## Response to the action items listed in the review committee's summary report

C. Lu, Princeton University

Arrangement of gas distribution/digital bubbler racks:

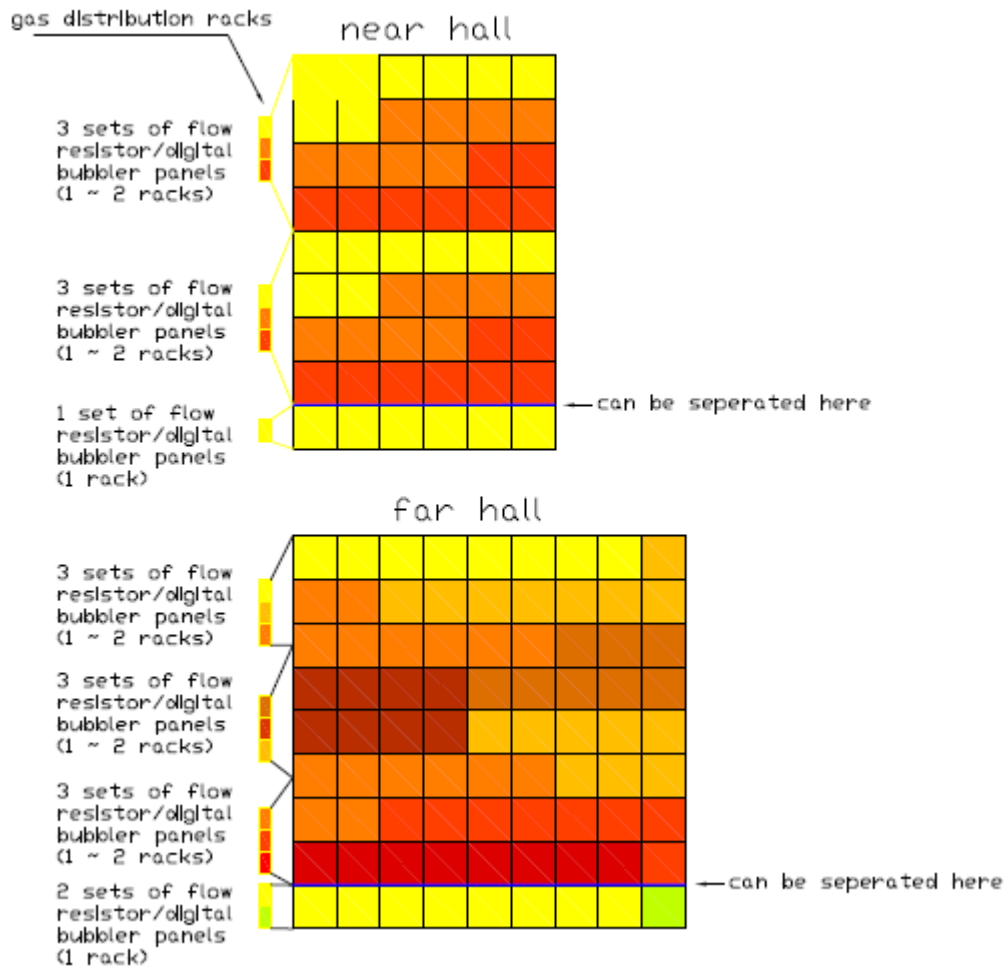
- Racks for mounting gas distribution crates, for near halls total 6 ~ 10 racks, for far hall total 4 ~ 7 racks are needed. (See the following plot for the arrangement of the racks)

Ralph mentioned at the FDR meeting that in order to be able to access AD at any location freely, he needs to separate the last 2m wide RPC supporting structure from the rest of the structure by ~2m, then insert a 2m wide bridge with working platform attached. Since the module number in each supporting structure either 6 or 9, not a multiple of 8, the gas distribution/digital bubbler crate are 16 channels (8 RPC modules) per each, therefore we have to arrange the gas distribution racks like the way shown above. The racks will be on the supporting frame. Except the last section can be moving away with the gas racks w/o interference, the other sections are not completely independent. The gas tubing will cross from one section to the next.
